ADDENDUM NO. 3

**Upgrades and Renovations
Missouri Veterans Home
Cape Girardeau, Missouri
Project No.: U1805-01 (FAI 29-043)**

Bid Opening Date: 1:30 PM, Tuesday, February 4, 2020

HARDSCAPE MATERIALS PLAN - NORTH

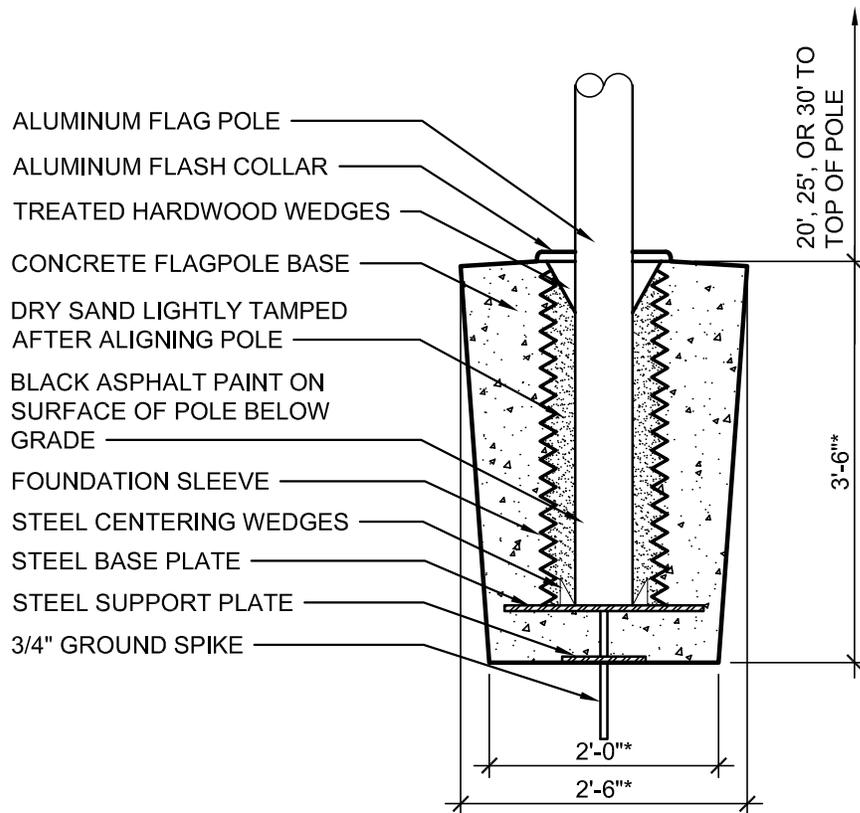
- a. REMOVE AND REPLACE Keyed Note 5 as indicated on attachment SD-L-101.1.
- b. ADD Keyed Note 6 as indicated on attachment SD-L-101.1.
- c. ADD Keyed Note 7 as indicated on attachment SD-L-101.1.
- d. ADD Keyed Note 6 and 7 to flag poles on plan as indicated on attachment SD-L-101.1.

- e. ADD General Note indicating that (30) Seasonal flag pole sleeves (see SD-L-202.2) to be included in base bid. Location to be determined by owner in field.

- 5. (2) DOWN LIT, ALUMINUM FLAG POLES. POLES TO BE 25' TALL. SEE DETAIL 2/L-202.
- 6. (1) DOWN LIT, ALUMINUM FLAG POLE. POLE TO BE 30' TALL. SEE DETAIL 2/L-202
- 7. (6) DOWN LIT, ALUMINUM FLAG POLES. POLES TO BE 20' TALL. SEE DETAIL 2/L-202.

- 1. (30) SEASONAL FLAG POLE SLEEVES TO BE LOCATED BY OWNER IN FIELD. SEE DETAIL 3/L-202

SD-L-202.1

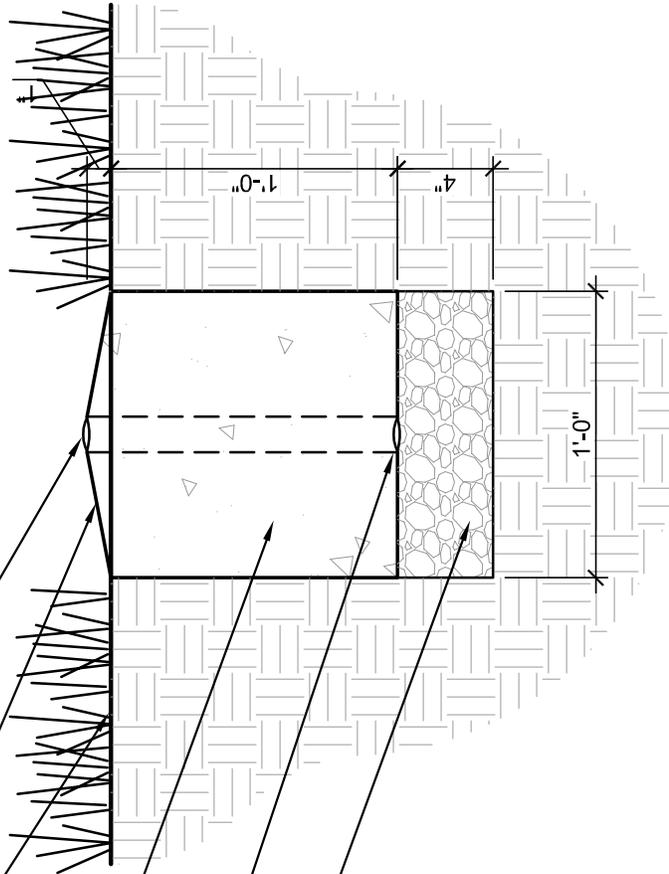
- a. REVISE Detail 2 flag pole footing as indicated on attachment SD-L-202.1 with the following:
 - i. ADD flag pole height dimension.
 - ii. ADD note for flag poles to be down lit.
 - iii. ADD referencing specification SECTION 107516 - GROUND SET FLAGPOLE.
- b. ADD Detail 3 - Seasonal flag pole sleeve as indicated on attachment SD-L-202.2.

1. SEE PLANS FOR POLE HEIGHTS
2. ALL FLAG POLES TO BE DOWN LIT
3. SEE SPECIFICATION 10 7516 FOR MORE INFORMATION

PVC SLEEVE, DIAMETER TO BE COORDINATED WITH OWNER TO FIT SEASONAL FLAG POLES. CONTRACTOR SHALL ENSURE SLEEVES ARE PLUMB

SD-S-201.1

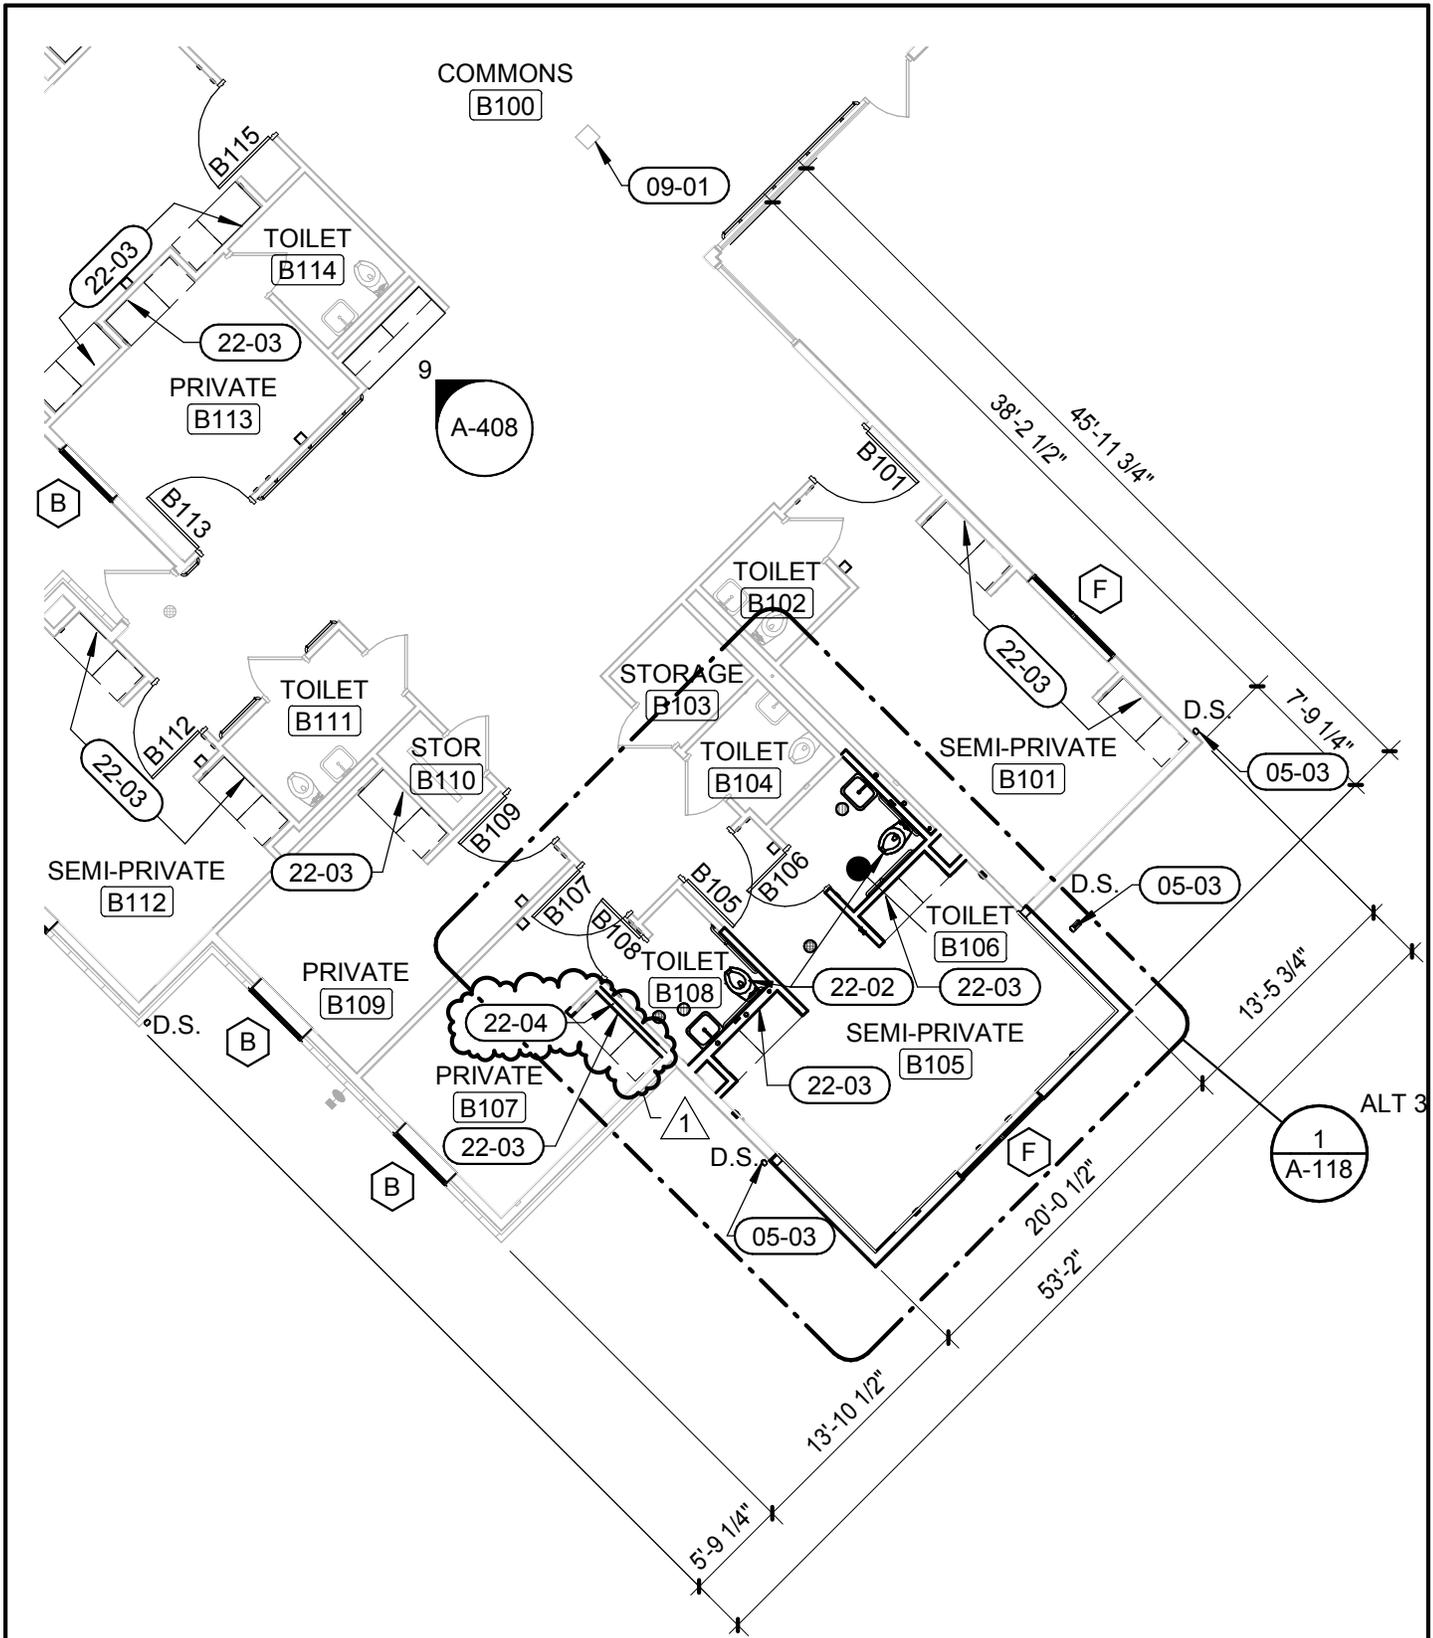
- a. REVISE Roof Framing Plan Note F as indicated on attachment SD-S-201.1.

SD-A-111.1

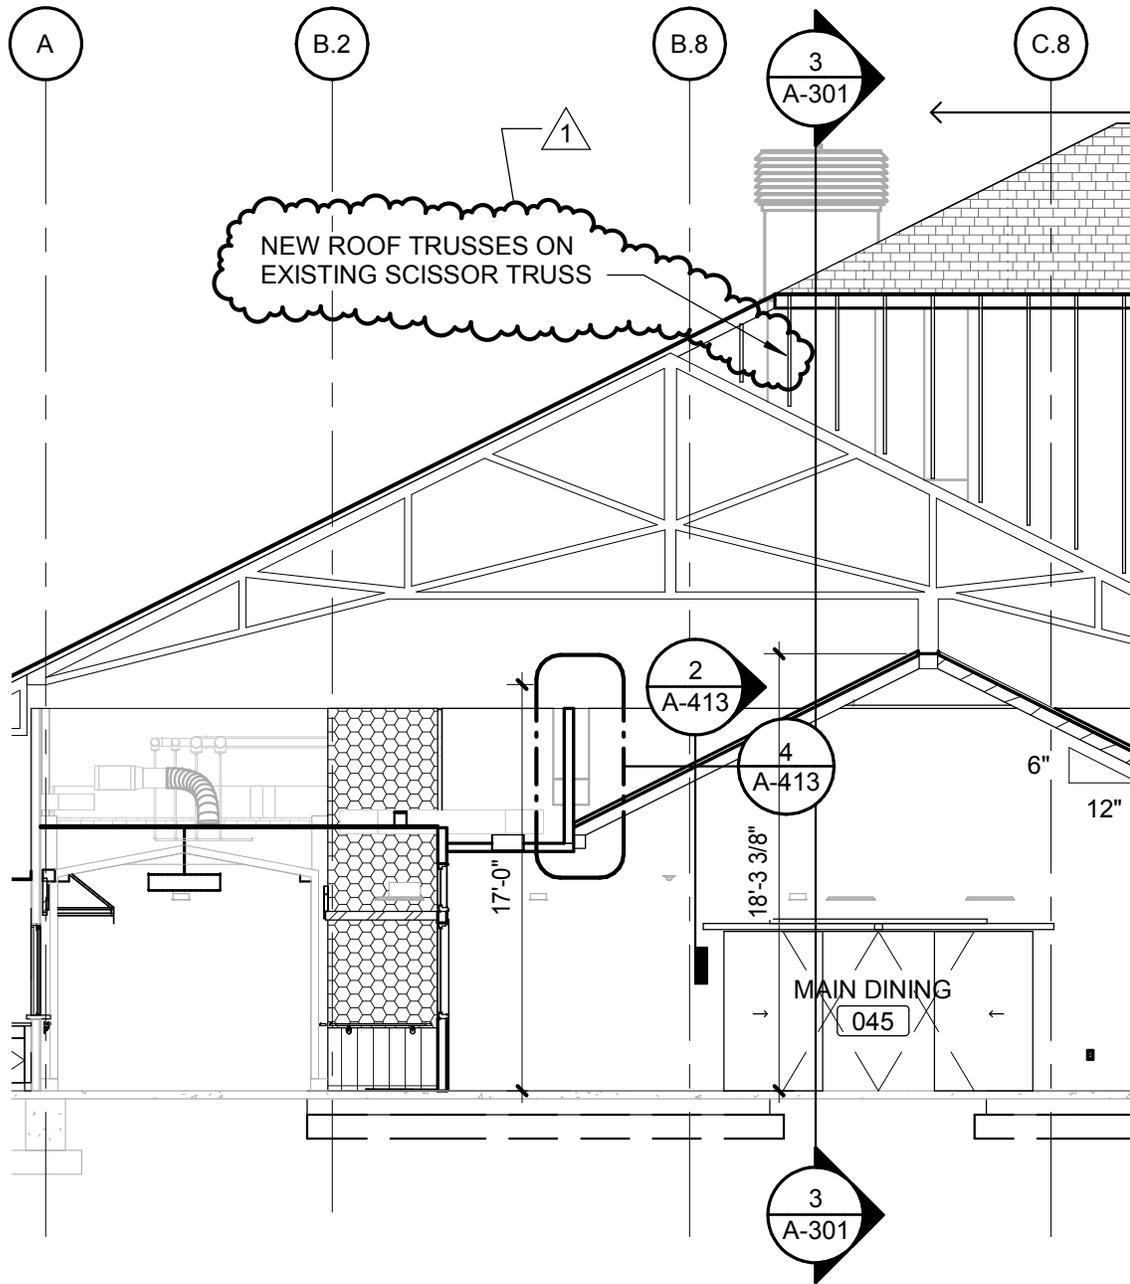
- a. ADD Wall furring for ALT. 1 pavilion cold water supply piping.
- b. ADD Keynote 22-04 as follows:

22-04	IF ALT. 3 IS NOT TAKEN, INSTALL NEW WALL FURRING (P8) FOR PLUMBING DROP. SAW CUT FLOOR AS INDICATED ON PLUMBING DRAWINGS
-------	--

SD-A-301.1

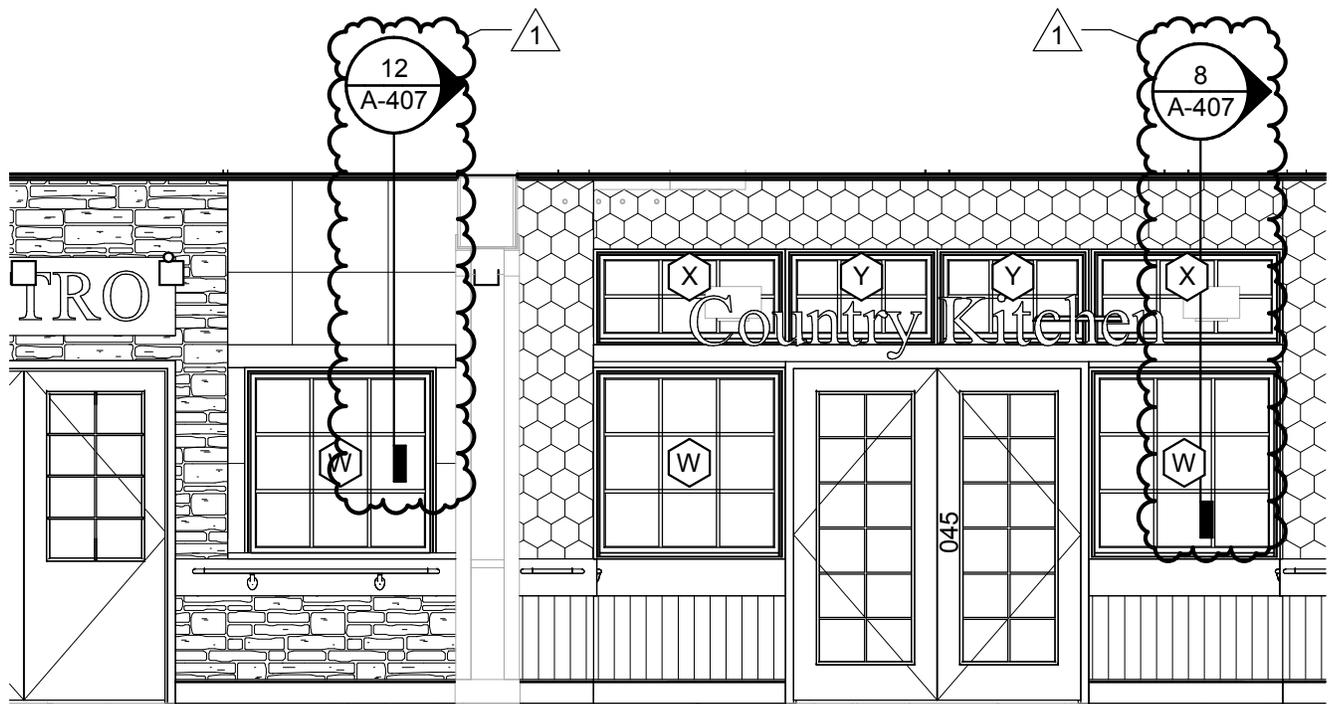
- a. REVISE Note on Building Section 1 as indicated on attachment SD-A-301.1.

SD-A-406.1

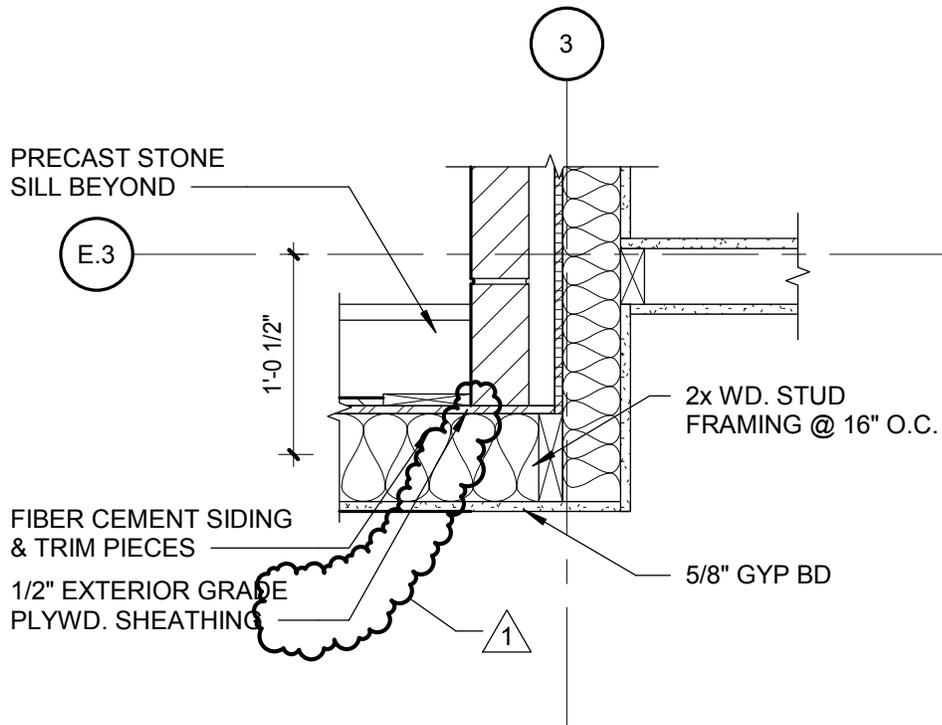
- a. ADD section cut references to Elevation 1 as indicated on attachment SD-A-406.1.

SD-A-501.1

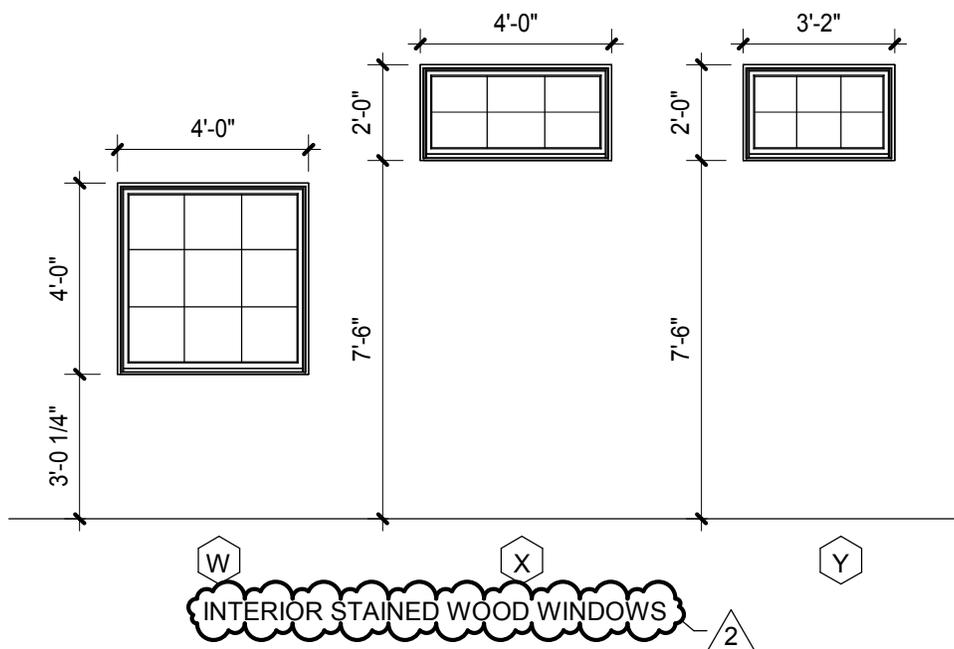
- a. REVISE note leader line to point to exterior plywood in lieu of interior gypsum board as indicated on attachment SD-A-501.1.

SD-A-603.3

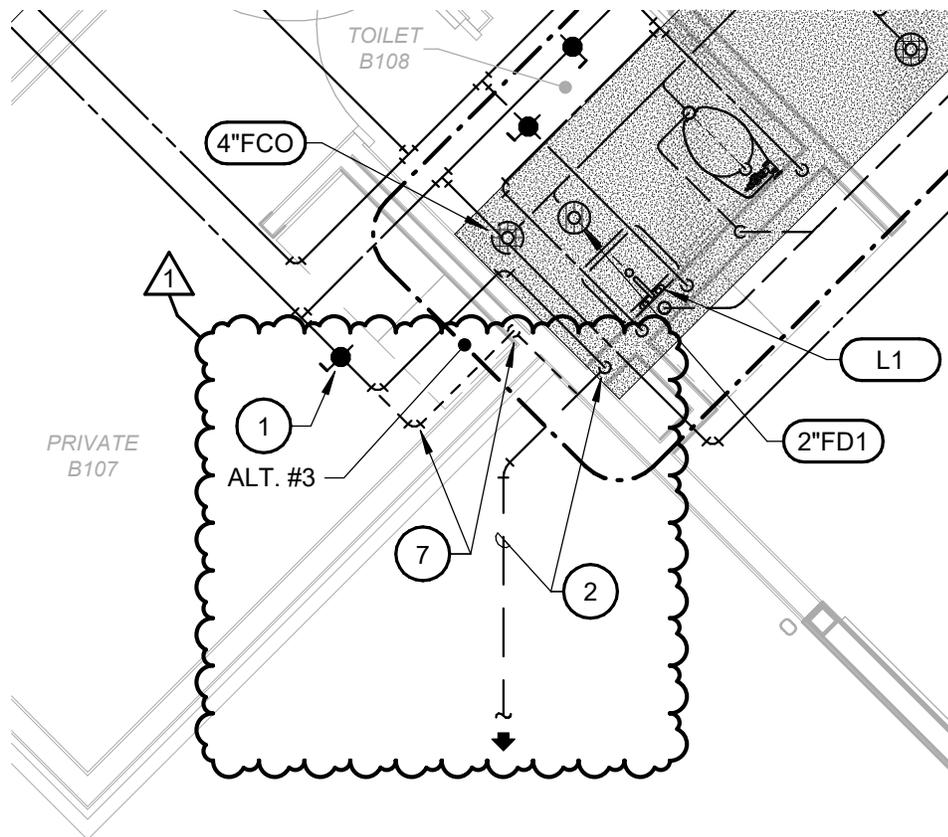
- a. ADD Note to window elevations W, X & Y as indicated on attachment SD-A-603.3.
